# BUILDING PERMIT

Located At 17 ATLANTIC ST

Job ID: 2012-04-3848-MF 3

has permission to Build an 8' shed dormer on southside of the 3<sup>rd</sup> floor unit  
provided that the person or persons, firm or corporation accepting this permit shall comply with all of the provisions of the Statues of Maine and of the Ordinances of the City of Portland regulating the construction, maintenance and use of the buildings and structures, and of the application on file in the department.

# Wall Detail

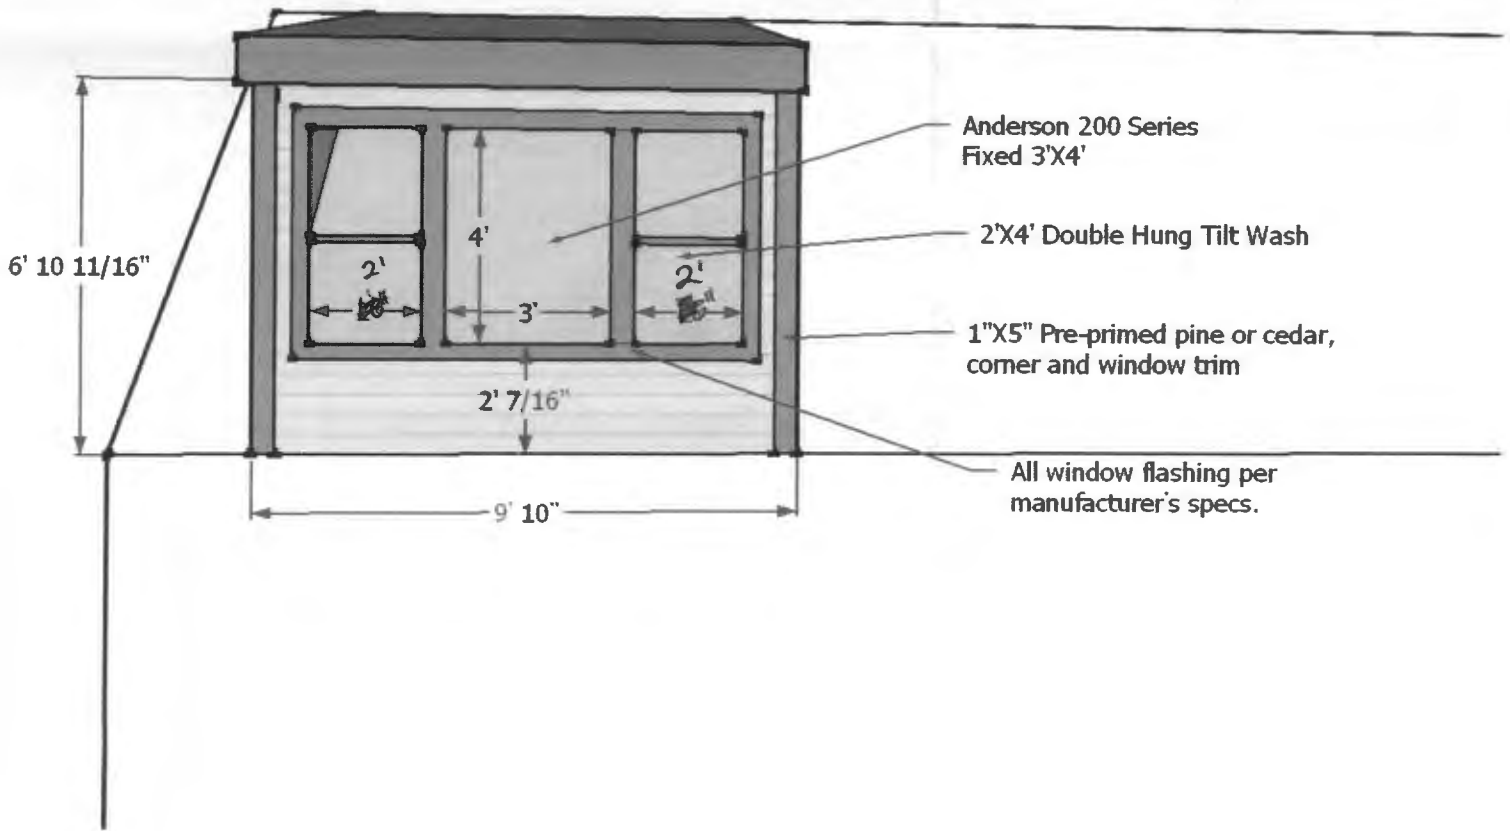
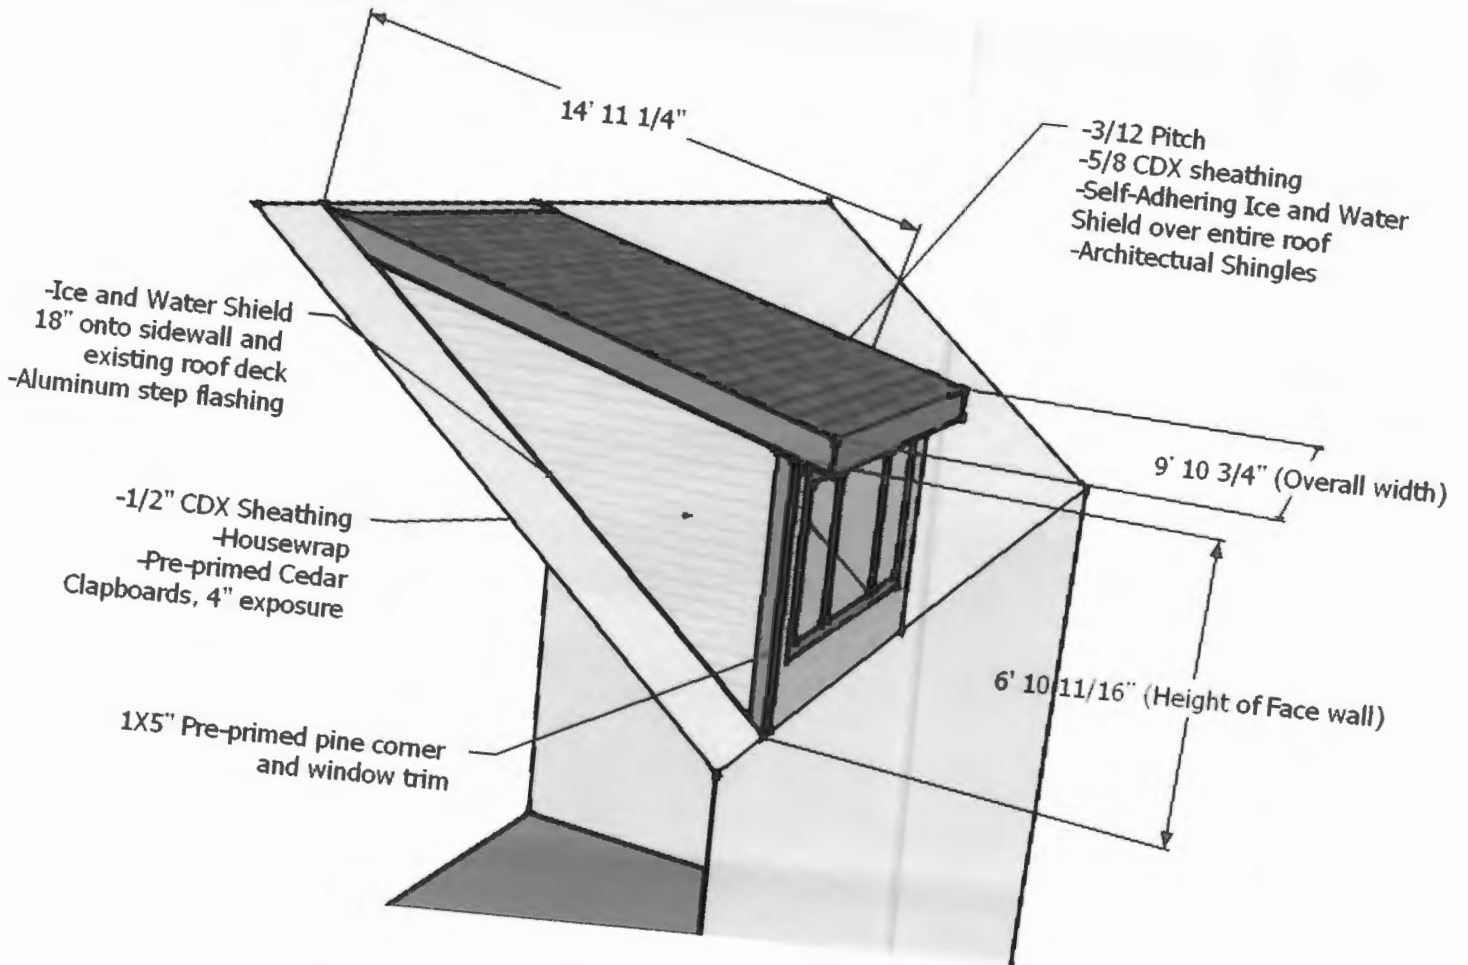
2. R- value. I will indicate the insulation system proposed on an updated drawing.

- The required R-20 in the wall does not allow calculation of other building materials, this is determined in the R-20 computation, IEEC Sec. 402.1.2.
- Can you please provide the U-factor of the windows?

WALL insulation R-20  
 R-19 fiberglass plus wall materials (+2.7R)

WALLS  
R-19 Batts  
and  
R-5 1/2" Foam Board

# Cross section / Framing Detail

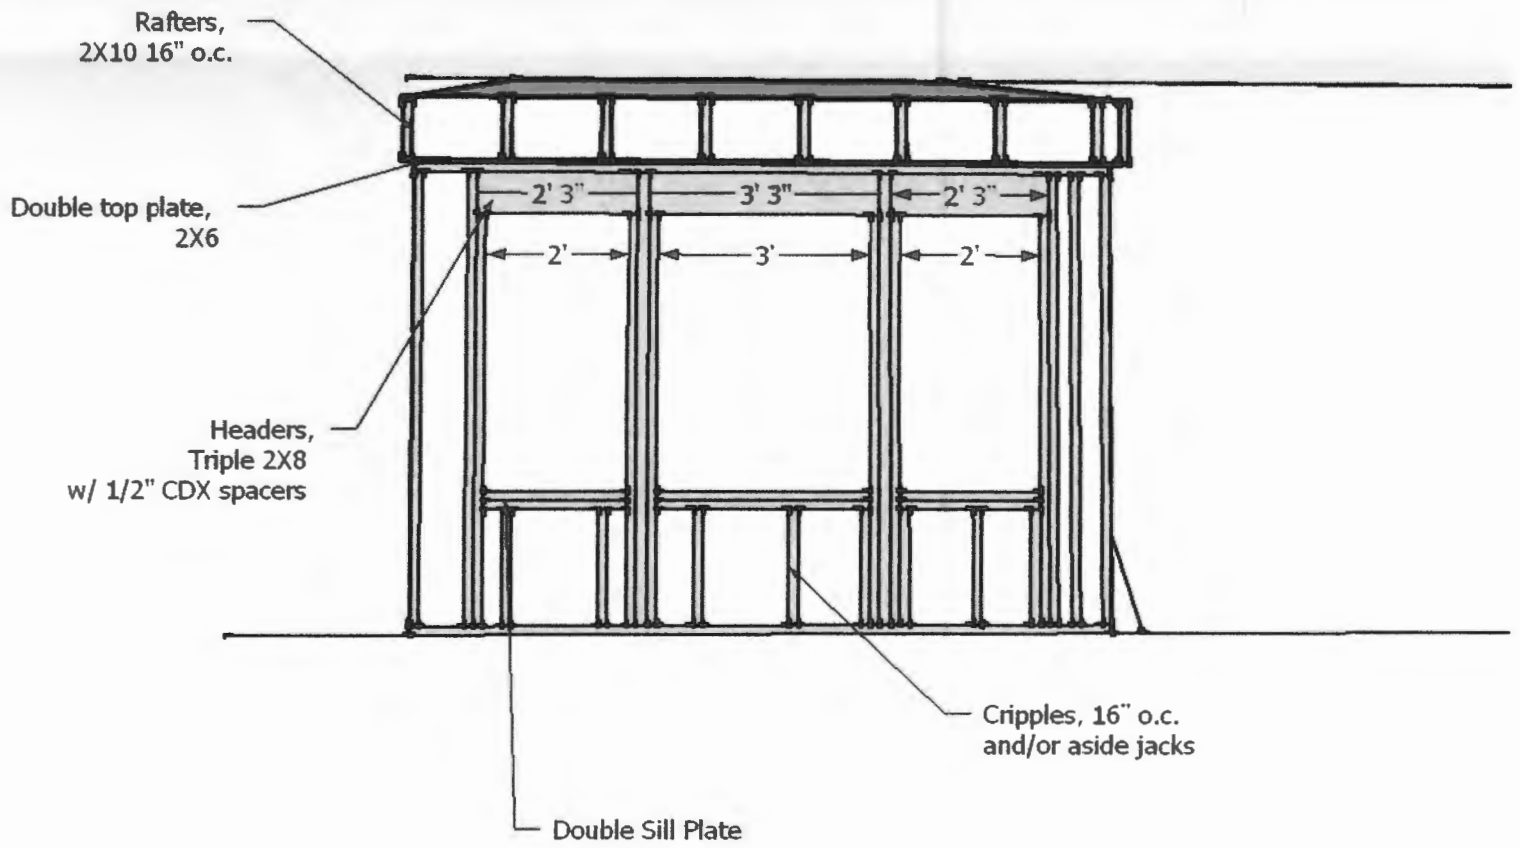
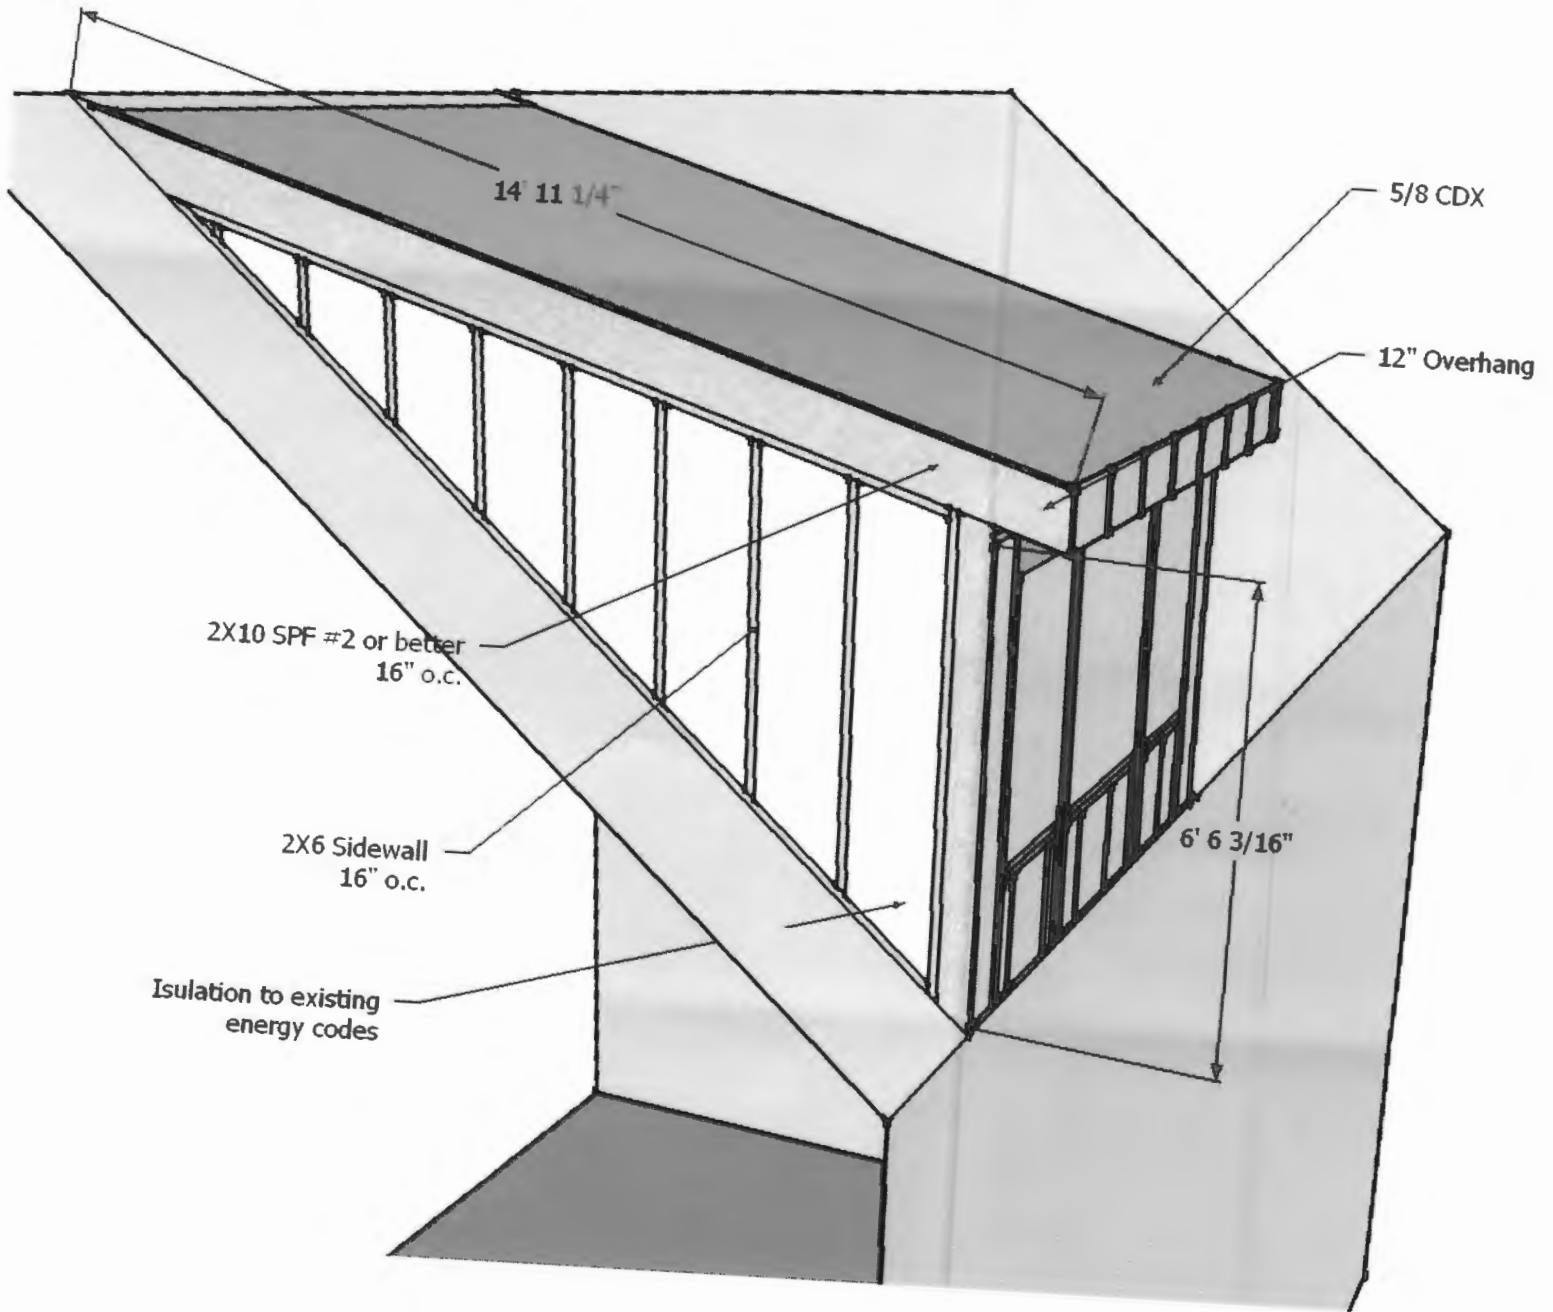
Thank you for the clarifying the existing situation, with the ceiling joists and beam. Can you please provide a revised section drawing with these specific details:

- the ridge beam dimension (is it a structural beam or a board?), the location of the ceiling joist attachment, dimension and spacing, the height of them off the floor, spec the type of rafter attachment to the beam

Proposed Deanne Roof Framing

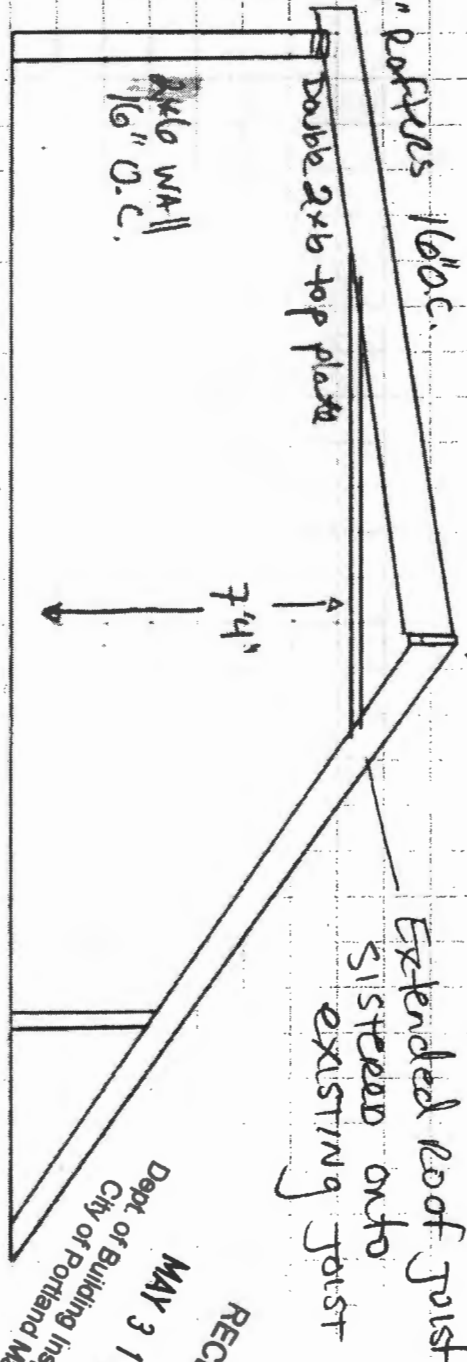
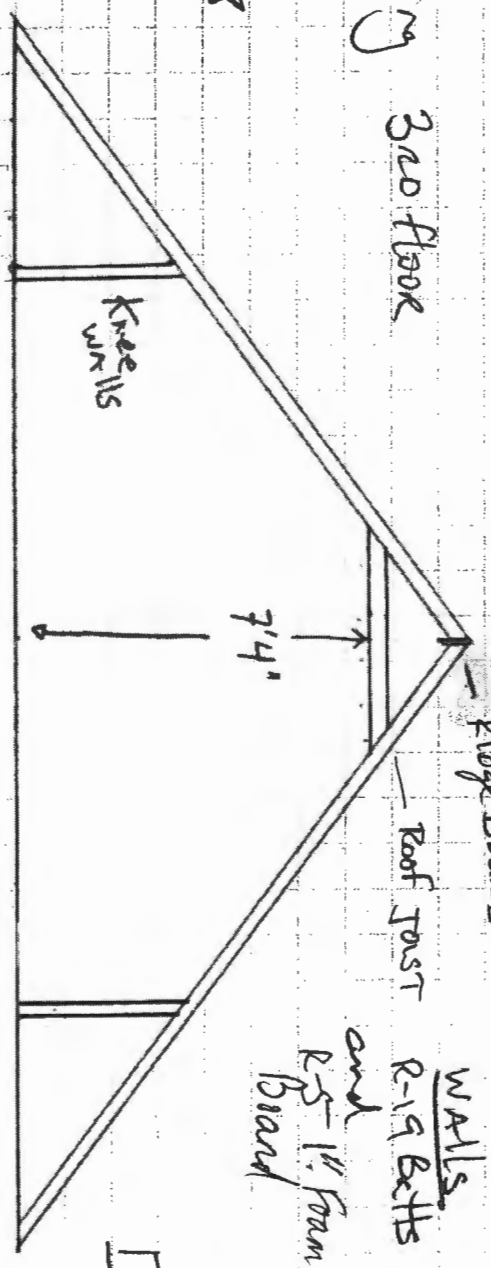
Thanks for the detail, due to the connection of the ceiling joists to the rafters, hanger brackets at the ridge are not required, however they are at the dormer wall.

Could you please confirm whether we need rafter brackets at the ridge and wall since we do not have a cathedral ceiling?

exterior wall plate to the rafter, Sec. 2308.10.1

Required  
2x10" rafters 16" o.c.

Please find attached a pdf of the roof framing detail we discussed on the phone. This includes the extension of the existing roof joists, ridge and joist brackets (if required), and insulation schedule for walls.
